Response from the authors for review of ‘Proposed improvement of the detection and measurements of light precipitation in the Canadian Arctic’.

Reviewer 1

Citation: <https://doi.org/10.5194/egusphere-2025-5195-RC1>

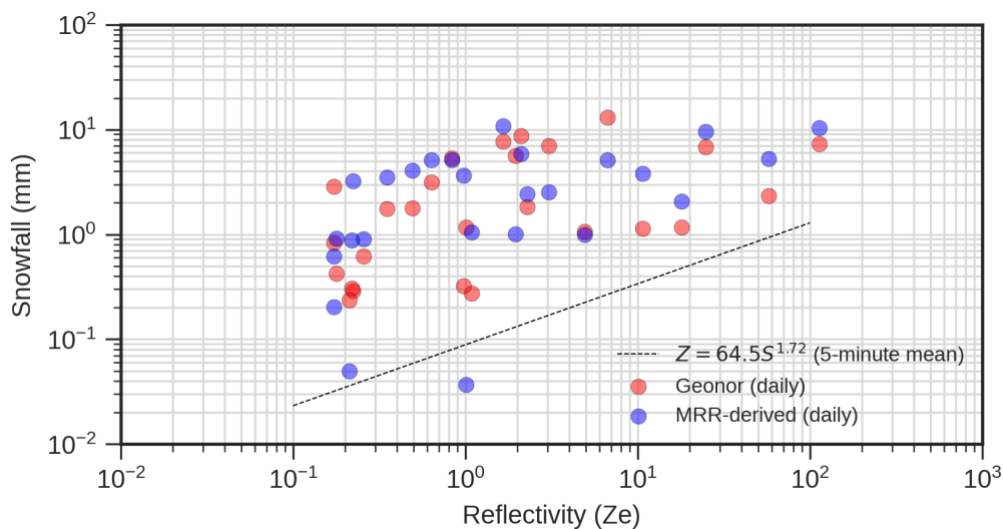
RC1.14 I210: the method to derive the Z-S relation seems very robust, but I would have liked to see the cloud point with the best fit to get an idea of the data dispersion. Besides, this relation is established on snow events only (i.e., precipitation strong enough to exceed the snow gauge threshold). Would you know if/how the results would be impacted when you fill the light precipitation events in the snow gauge data, using the MRR light precipitation computed from heavier precipitation?

Thank you for this suggestion. We produced the requested figure (shown below), however, in doing so we realized that our original description of the methodology was not sufficiently clear. The figure appears different from a conventional Z-S relationship because the coefficients a_{zs} and b_{zs} were **not** derived by fitting a regression to concurrent reflectivity and snowfall observations.

Instead, the coefficients were obtained through an optimization procedure designed to reproduce accumulated snowfall. Following Schoger et al. (2021), MRR effective reflectivity from the 105, 140, and 175 m range gates was first averaged over five-minute intervals. We then performed an exhaustive parameter search by evaluating 10,000 candidate Z - S relationships, using 100 uniformly spaced values of a_{ZS} between 10 and 100 and 100 uniformly spaced values of b_{ZS} between 1.0 and 2.0. For each candidate relationship, every five-minute reflectivity observation was converted to snowfall using Eq. (3), and the resulting five-minute snowfall estimates were summed to daily accumulations. These daily MRR-derived accumulations were then compared with the corresponding daily accumulations measured by the adjusted Geonor gauge. The optimal coefficient pair was selected by maximizing the coefficient of determination (R^2) while simultaneously minimizing the RMSE and the difference in total seasonal snowfall.

The attached figure illustrates why this optimization differs from the conventional derivation of a Z - S relationship. The dashed line represents the optimized relationship ($a_{ZS} = 64.55$, $b_{ZS} = 1.72$), while the red and blue points represent the observed Geonor daily snowfall totals and the corresponding MRR-derived daily snowfall totals, respectively, plotted against the mean five-minute MRR reflectivity for each day. Because the optimization was performed on the **daily accumulated snowfall obtained by integrating all five-minute estimates throughout each day**, rather than by fitting a regression to the daily mean reflectivity, the optimized coefficients are **not expected to pass through the centre of this scatter**. Consequently, this figure should not be interpreted as a conventional reflectivity-snowfall regression.

For this reason, we believe that including this figure without the accompanying explanation could inadvertently suggest that the coefficients were derived using a conventional regression-based approach, which was not the case. Instead, we have substantially revised the Methods section to clarify the optimization procedure used to derive the coefficients and to explicitly distinguish it from the conventional regression-based derivation of a Z - S relationship.
